## DEVIATION REQUEST AND DECISION FORM

Project Name : Waterbury Filings 1 and 2

A deviation from the standards of or in Section 2.3.7.E.1 & 2 of the Engineering Criteria Manual (ECM) is requested. The requested deviation is to allow left- and right-turn bays on the southbound Saybrook approach to Stapleton to be designed for required stacking/storage distance plus a compact bay taper design in order to minimize the impact to on-street parking and lots fronting Saybrook.

The first attached exhibit is a copy of the laneage exhibit depicting the deviation request. The second exhibit is a copy of the Saybrook proposed cross section with on-street parking and lot frontage that would be impacted without this deviation.

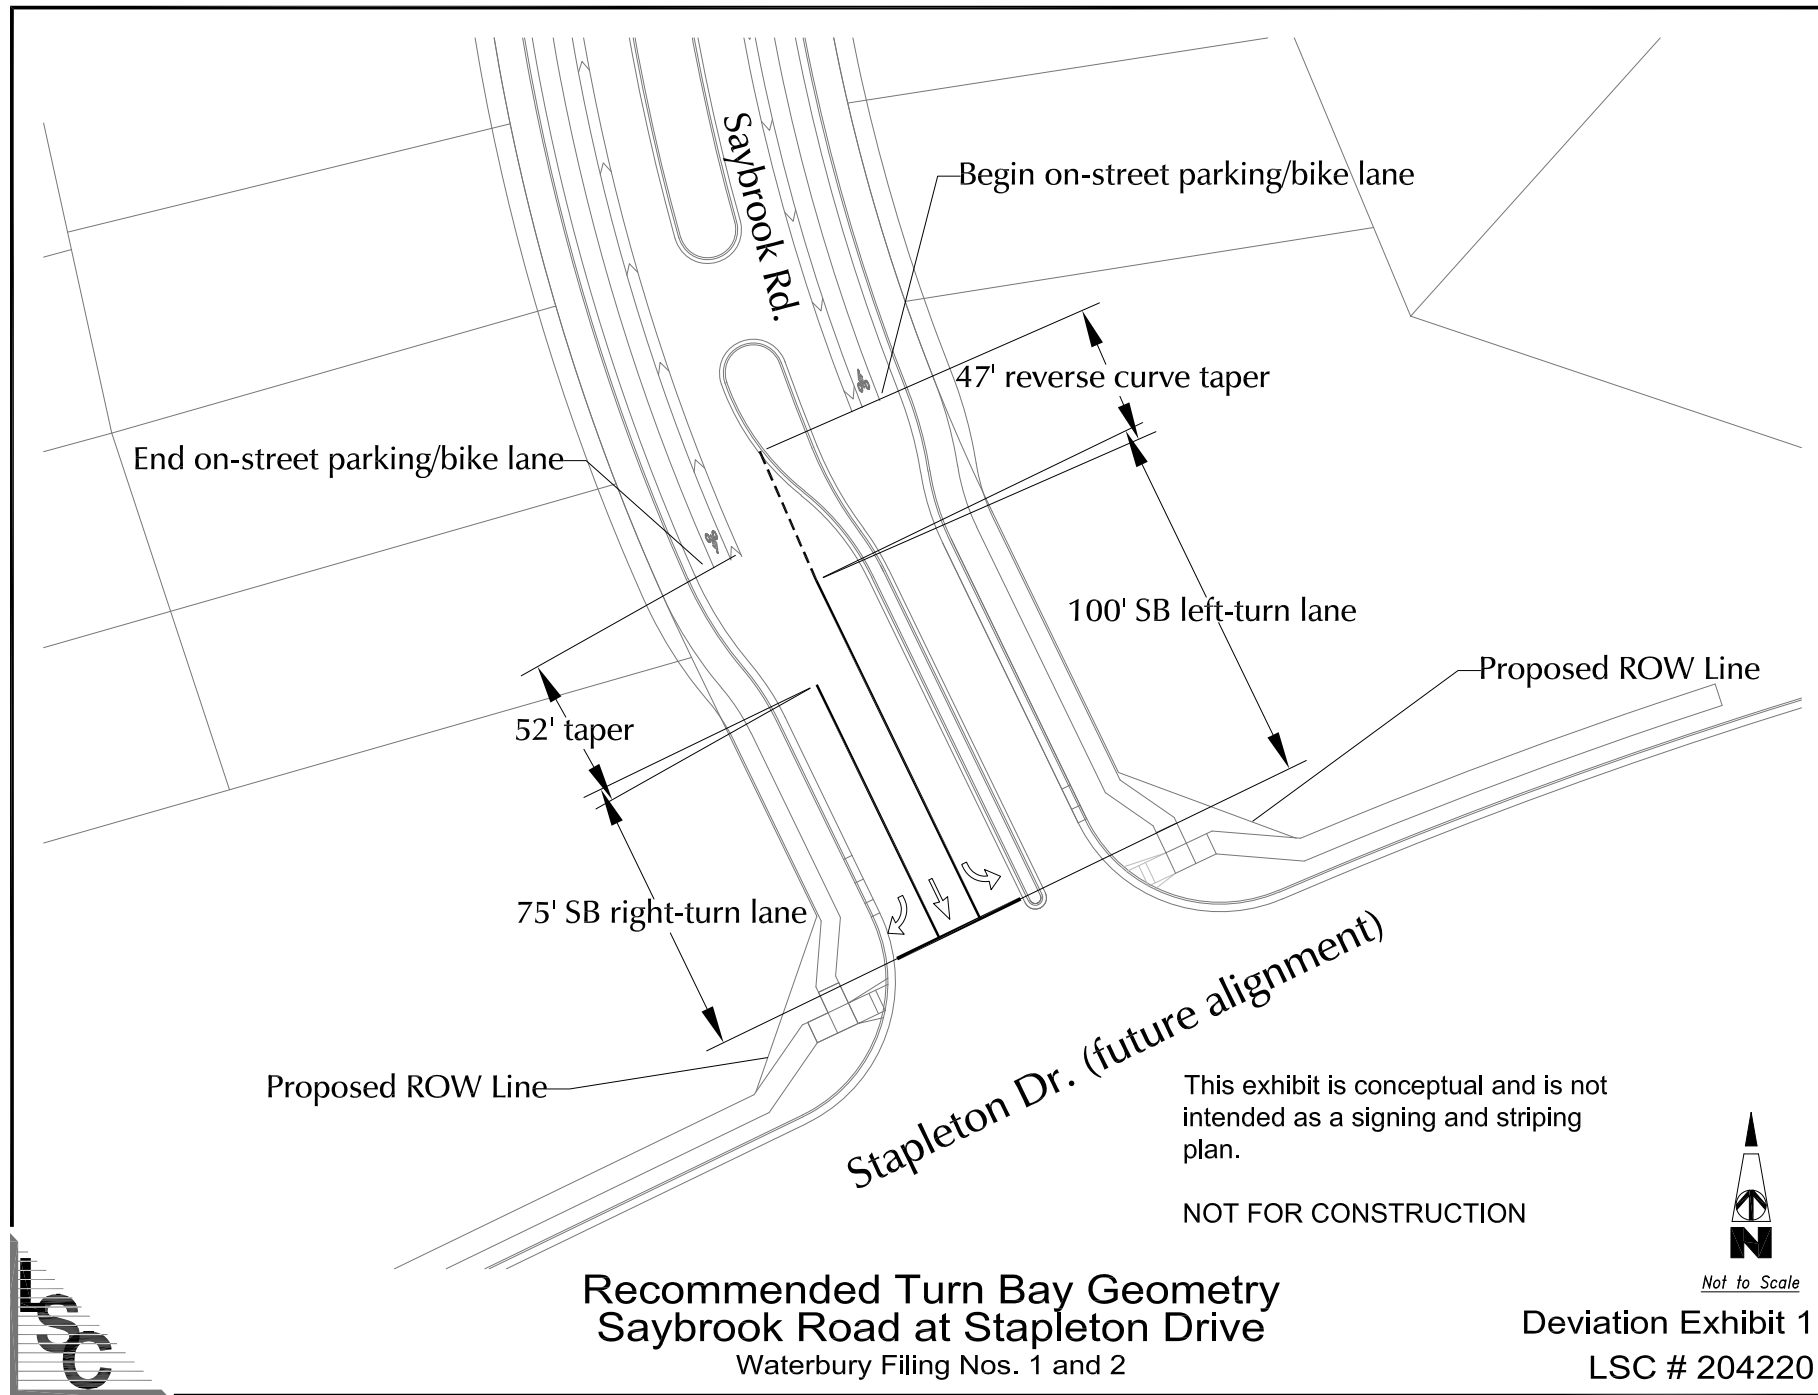
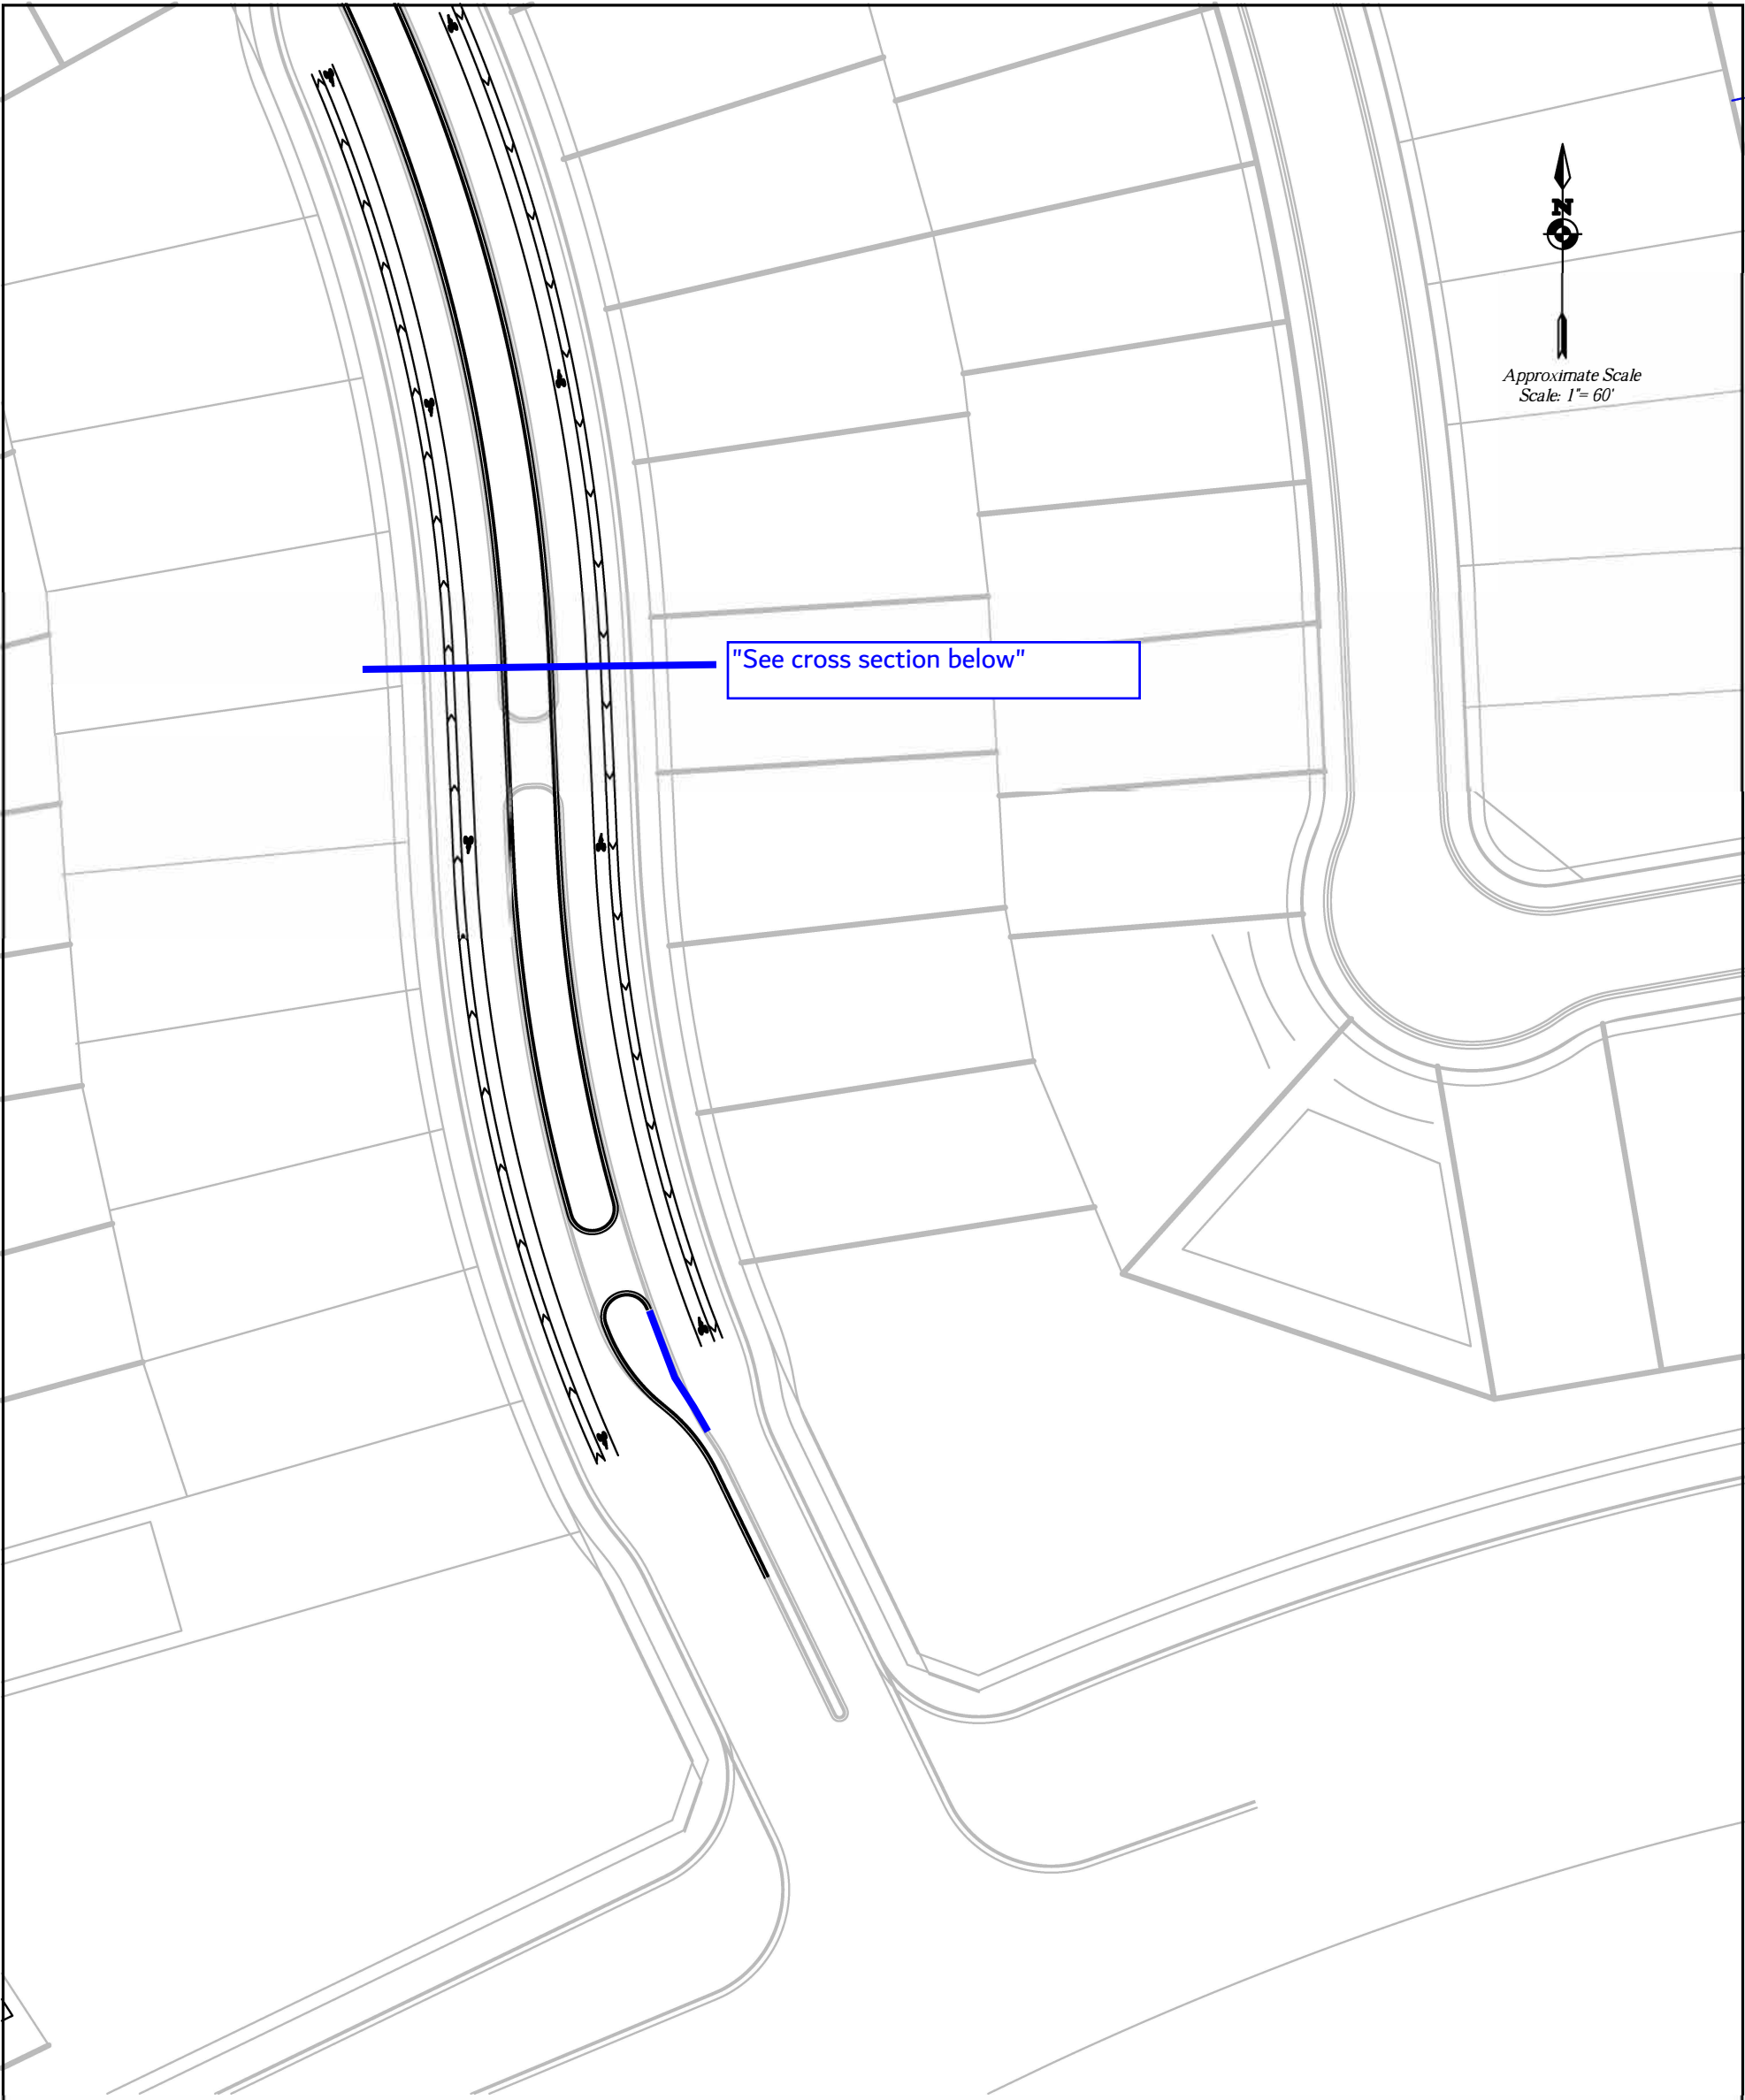
The ECM requires turn lanes to include deceleration distance plus stacking distance plus taper length. Based on a design speed of 30 mph (posted speed would also be 30 mph) and the turning volumes, the ECM criteria for turn lanes requires a southbound right-turn lane length of 165 to 190 feet (115 feet of deceleration distance plus 50 to 75 feet of storage) plus a 120-foot taper for a total right turn length of 285 to 310 feet and a southbound left-turn lane length of 165 to 190 feet plus a 120-foot taper for a total left turn length of 285 to 310 feet. The proposed left- and right-turn lanes are 100 feet long plus a 60 foot compact bay taper for a total lane length of 160 feet. This is 125 to 150 feet shorter than the ECM criteria.

All the above factors make this situation different from an access or intersection along a higher speed collector or arterial where a deceleration length component is important. The deviation exhibits show both southbound and left- and right-turn bays on Saybrook on the approach to Stapleton. The southbound left-turn lane would have sufficient stacking length to accommodate over 95 percent of the southbound left vehicle queues during the peak hour. The southbound right-turn lane would have sufficient stacking length to accommodate the southbound right-turn vehicle queues. Both lanes would be of sufficient length such that the entry to the lanes would not be blocked by the southbound through lane queue except perhaps in an unusual situation.

**Approved by the ECM Administrator**

"See cross section below"

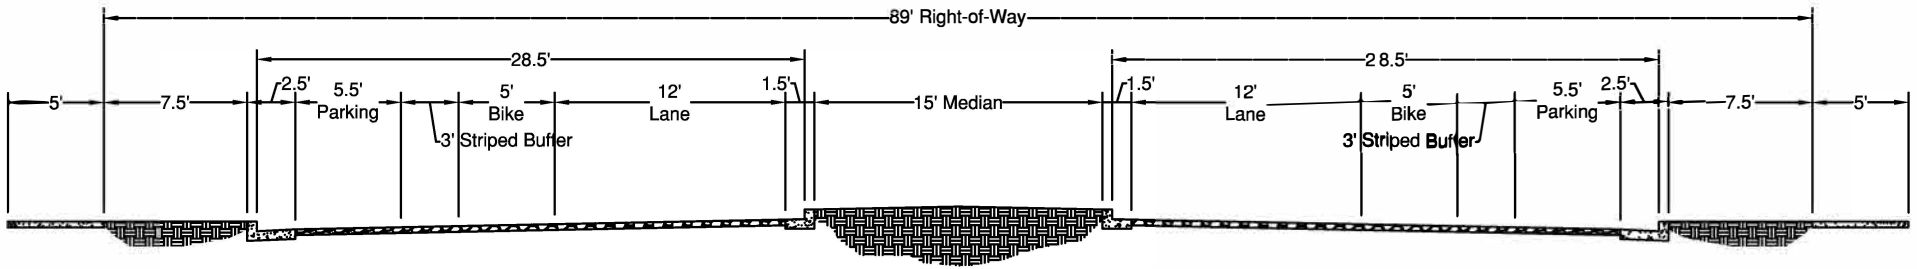
The deviation is needed to minimize the impact full-length, standard turn lanes would have to on-street parking and lots fronting Saybrook (please refer to the attached deviation exhibits).

**Recommended Turn Bay Geometry  
Saybrook Road at Stapleton Drive**

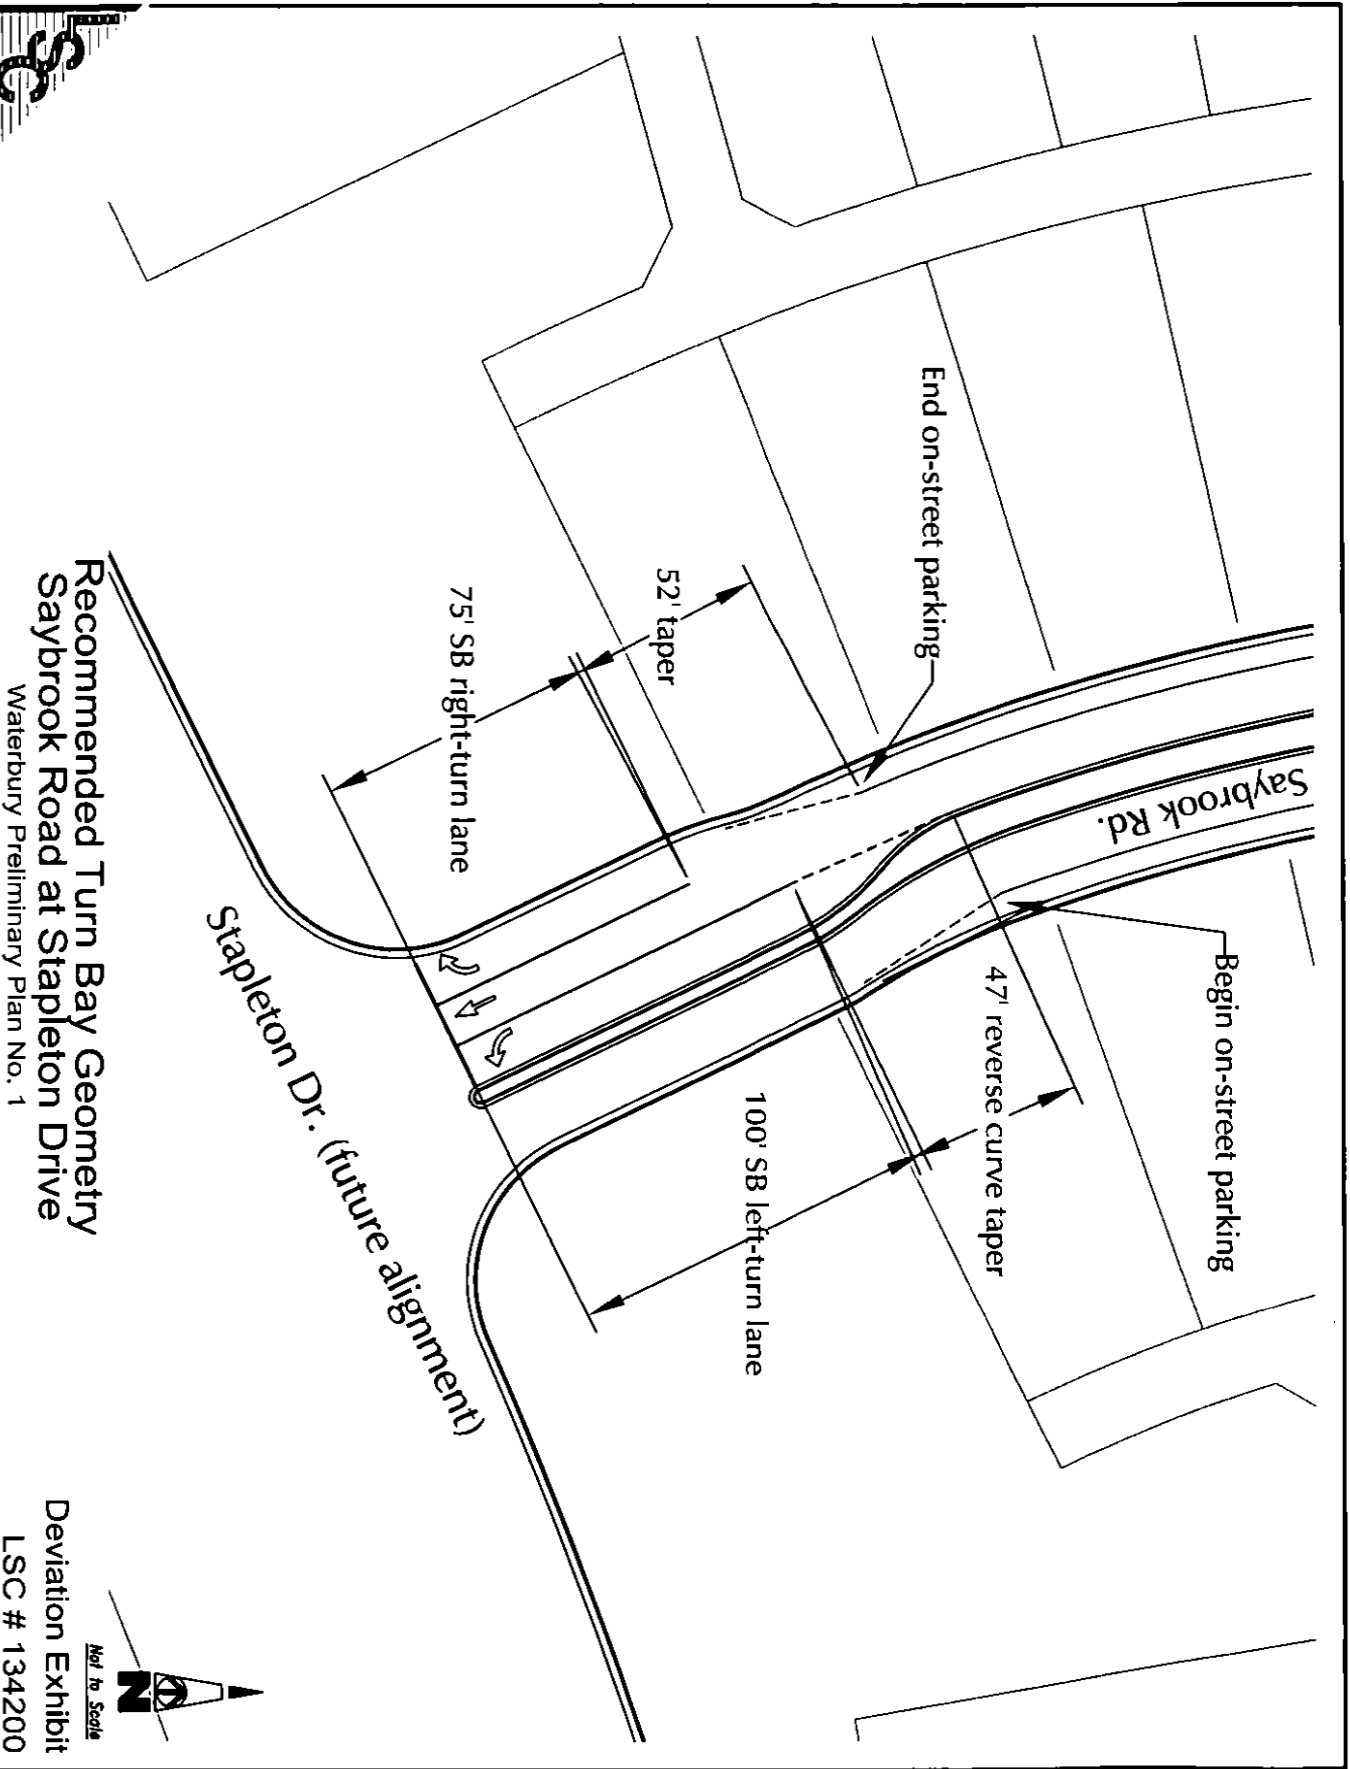
Proposed Nature and Extent of Deviation: The requested deviation is to allow left and right turn bays on the southbound Saybrook approach to Stapleton to be designed for required stacking/storage distance plus a compact bay taper design in order to minimize the impact to on-street parking and lots fronting Saybrook (see attached exhibit)

Comparison of Proposed Deviation to ECM Standard: The ECM requires turn lanes to include deceleration distance plus stacking distance plus taper length. Based on a design speed of 30 mph (posted speed would also be 30 mph) and the turning volumes, the ECM criteria for turn lanes requires a southbound right-turn lane length of 165 to 190 feet (115 feet of deceleration distance plus 50 to 75 feet of storage) plus a 120-foot taper and a southbound left-turn lane length of 165 to 190 feet plus a 120-foot taper. LSC's judgment is that given the particular situation, these lane lengths could be shortened to provide stacking distance only. Note: The traffic simulation actually indicates a 2035 need for about 100 feet of stacking to accommodate the projected queues, rather than 50 to 75 per ECM

This request has been determined to have met the criteria for approval. A deviation from Section 2.3.7.E.1+2 of ECM is hereby granted based on the justification provided. Comments:
